TO: Planning & Zoning Commission
FROM: Shane Graham, Planner II
DATE: March 21, 2019
SUBJECT: Ashley Furniture Homestore Site Plan Review

REQUEST: Request to approve an S-1 Shopping Center District site plan for the reuse of the former Younkens building at College Square Mall.

TO: Planning & Zoning Commission
FROM: Shane Graham, Planner II
Matt Tolan, Civil Engineer II
DATE: March 21, 2019
SUBJECT: Ashley Furniture Addition, Preliminary & Final Plats

REQUEST: Request to preliminary and final plat one (1) lot as the Ashley Furniture Addition.

Exhibit from Developmental Procedures Agreement showing the parking lot areas to be addressed on the Younkers site.

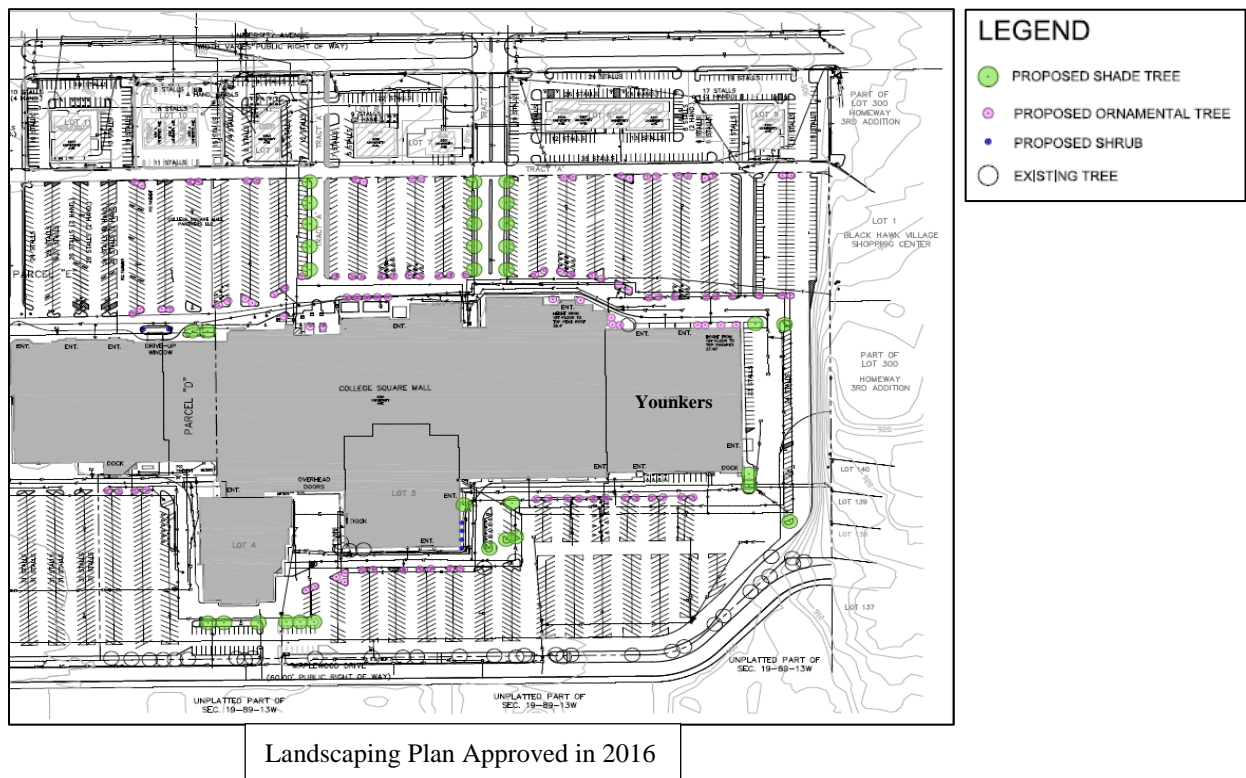
Parking Lot Repair – The Developmental Procedures Agreement that was approved in 2016 included making repairs to certain areas of the parking lot and backage road of the mall property. There are 4 locations on what would be the new parcel for Ashley Homestore that are required to be addressed per the Agreement: the north-south drive lane in front of the Younkers building (#2 in the image to the right), which was required to be overlaid with asphalt, the parking area at the northeast corner of the property (#1 in the image to the right), which was to be overlaid with asphalt, and two smaller areas along the east side of the property (#9 and #10 in the image to the right), which were to have potholes filled. After a site visit by staff, it appears that the small holes along the east side of the property have been filled, but the drive lane and area at the northeast corner of the property have not been overlaid with new asphalt. The developer does plan on overlaying this area with new asphalt, per the Developmental Procedures Agreement.

ASHLEY HOME STORES
 CEDAR FALLS, IA
 LANDSCAPING PLAN

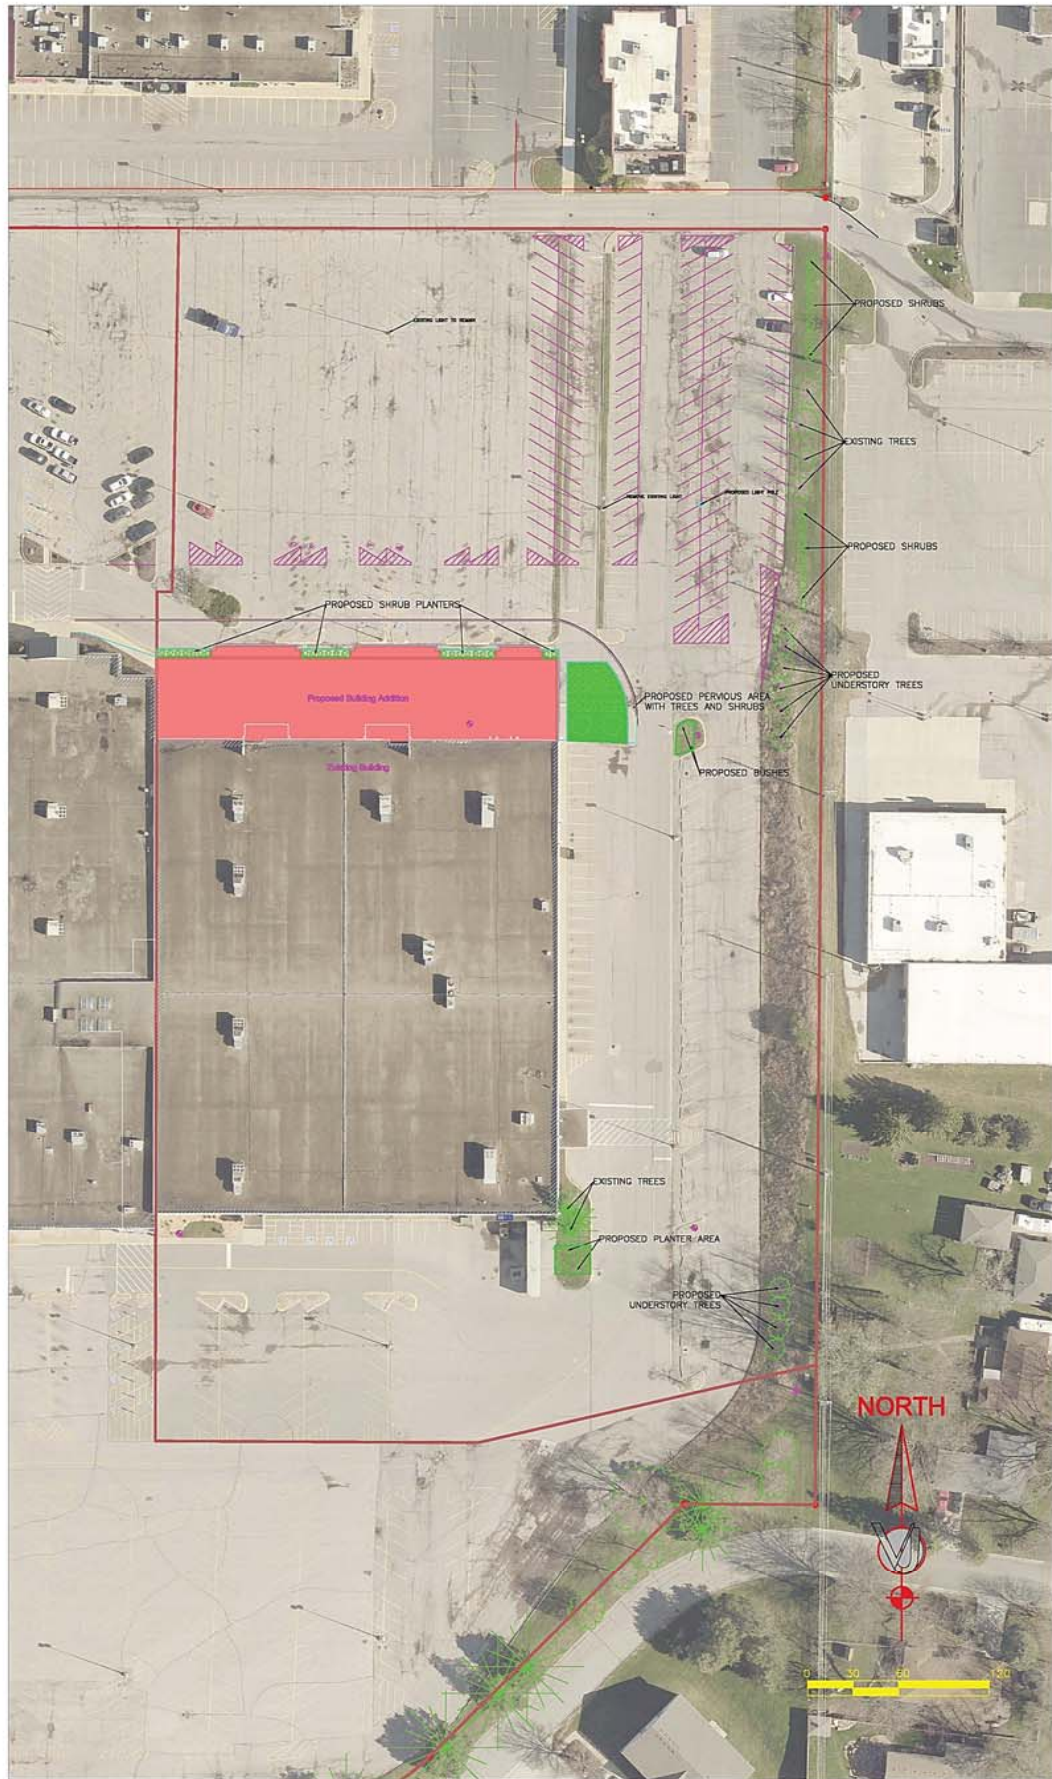
As an alternative to the parking lot islands and trees that are required per the Developmental Procedures Agreement, the developer has submitted a landscape plan that shows additional landscaping along the east property line within the

existing greenspace area, shows new planters in front of the building between the sidewalk and the building, shows added trees and shrubs within a new greenspace area near the northeast corner of the building, and shows a new planter area within the existing greenspace area at the southeast corner of the building. The provided landscape plan does indicate the location of the proposed plantings, however staff would like to see a more refined landscape plan that defines the types of plantings proposed (overstory tree, ornamental tree, shrub, etc.), the species of the planting, and the size (caliper of trees, gallons for shrubs). A more refined landscape plan which shows the above mentioned items can help staff and the planning and zoning commission better visualize and determine whether their alternative landscaping proposal will be an adequate substitute for the landscape plan that is required per the current Developmental Procedures Agreement.

1. Resubmittal of a more refined landscape plan, which defines the types of plantings proposed (overstory tree, ornamental tree, shrub, etc.), the species of the planting, and the size (caliper for trees, gallons for shrubs).
2. Submittal of a finalized storm water management report and detailed construction plans prior to issuance of a building permit.
3. Any comments or direction specified by the Planning & Zoning Commission.

REA boundary (yellow) and ECR boundary (red)

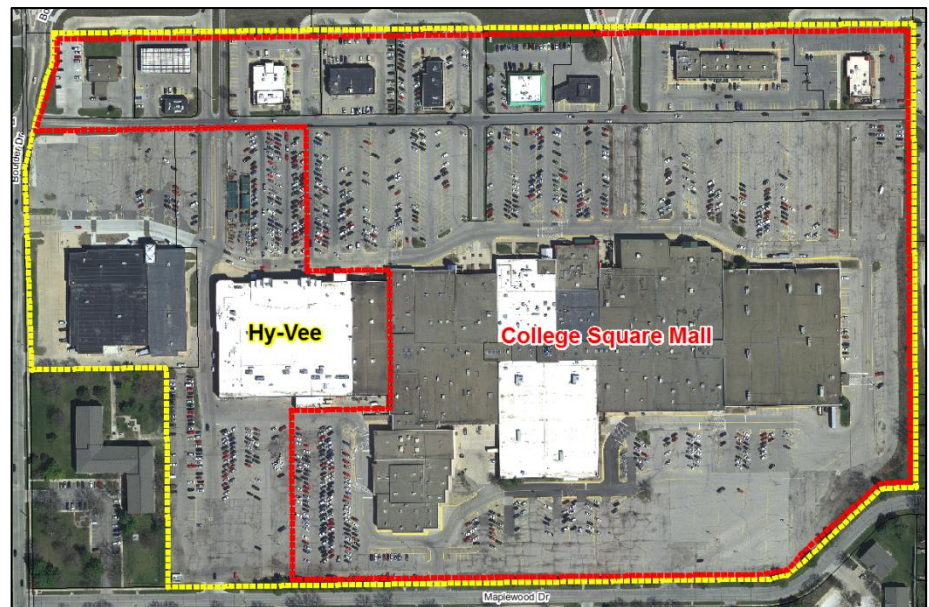
Staff will be reviewing these agreements to ensure that when the new parcel is created, it will still be subject to the restrictions found in both the REA and ECR or if any modifications to those agreements are necessary.

Preliminary Plat
Ashley Furniture Addition
A part of Lot 1, College Square Mall Addition
Cedar Falls, Black Hawk County, Iowa.

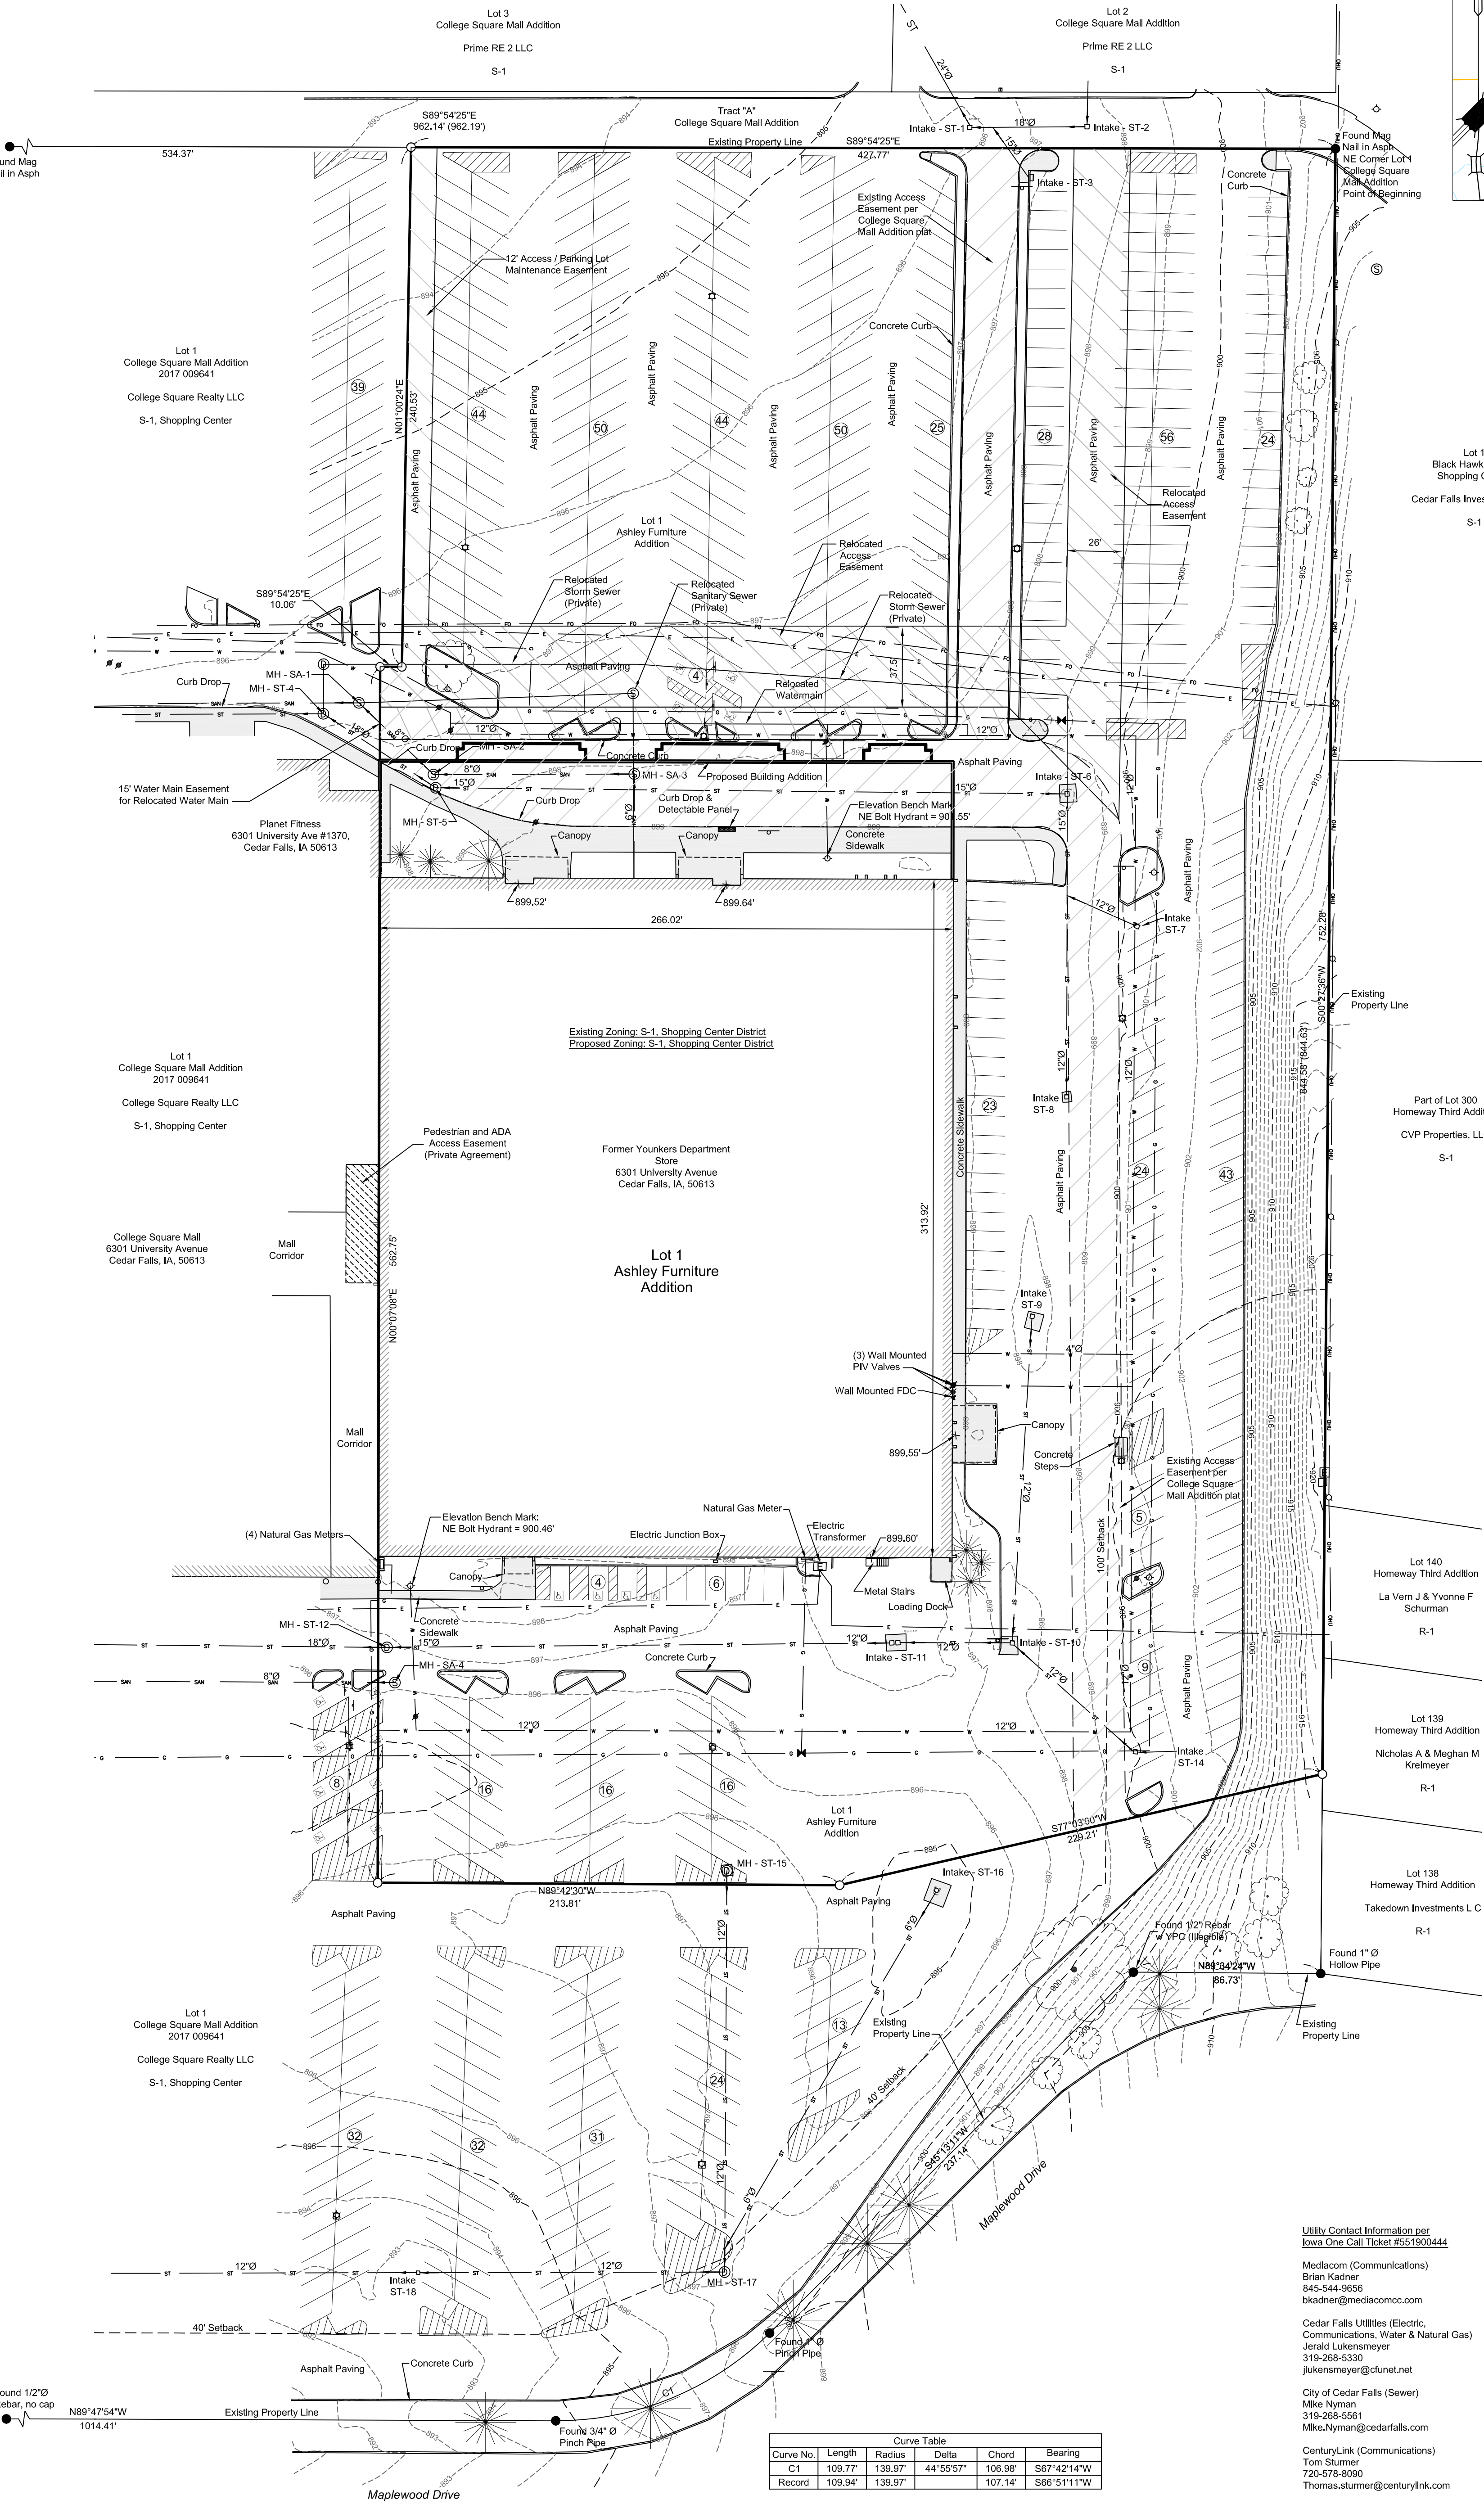
The existing access easement that covers the mall property was indicated by a sketch on a site plan showing where the common access drives were located on the mall property. Staff is checking the original plat to determine if easements were legally described and recorded to determine if any existing easements need to be vacated. Because the cross access easement on this proposed lot will be separate from the mall property, the easement will need to be shown on the plat and legally described and recorded.

1. Provide a legal description for the cross access easements on the lot and vacate any easements rendered obsolete with this plat.
2. Address any additional comments made by the City Surveyor after a re-review of the submitted plats.
3. Provide a title opinion for the property, owner's certificate and other legal papers required for the final plat.
4. Deed of Dedication – final corrections
5. Review of existing ECR and REA to address any necessary amendments.
6. Submittal of a final storm water management report and detailed construction plans prior to issuance of a building permit.
7. Submittal of two (2) signed Certificates of Survey and Six (6) signed full sized copies of the final plat prior to City Council submittal.
8. Any comments or direction specified by the Planning & Zoning Commission.
